CHEROKEE NATION ENTERTAINMENT  
TAHLEQUAH CASINO  
TAHLEQUAH, OKLAHOMA

PROJECT NAME  
BID PACKAGE 05

PROJECT FRAME  
ADDENDUM #15

MECHANICAL PIPING DIAGRAMS

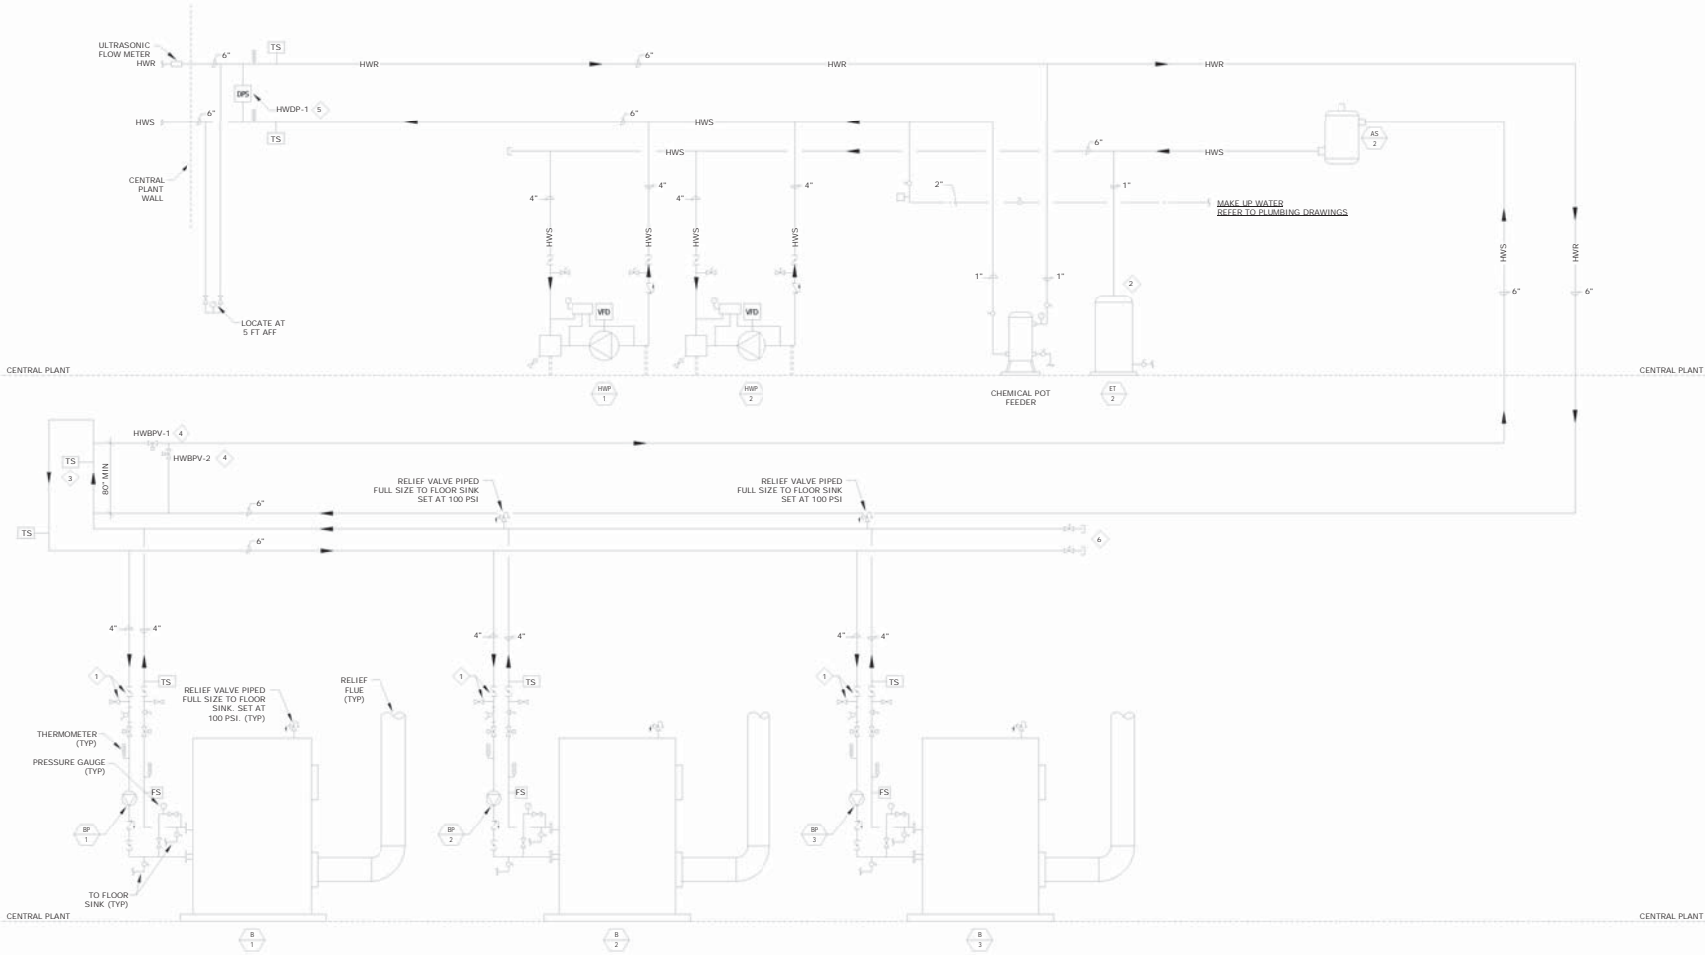
REVISIONS  
ENTIRE SHEET

MECHANICAL ENLARGED FLOOR PLAN - GAMING  
 1/8" = 1'-0"

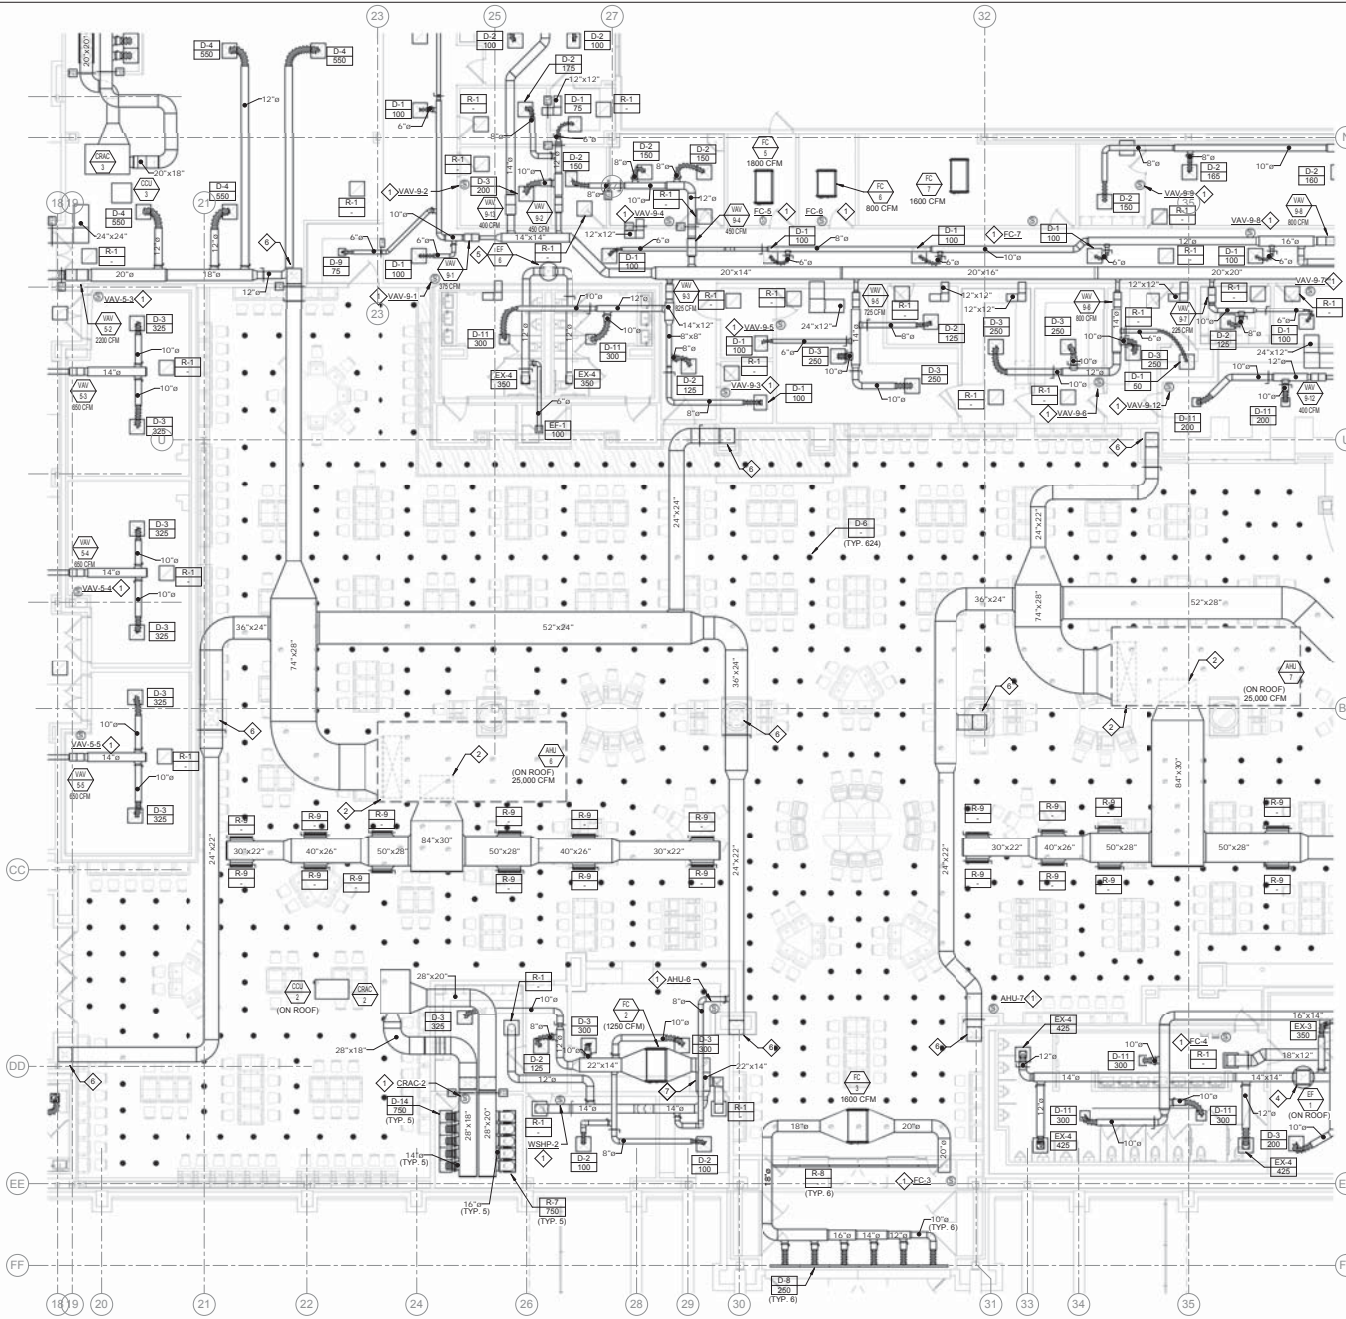
ENTIRE SHEET  
 REVISED ENTIRE SHEET
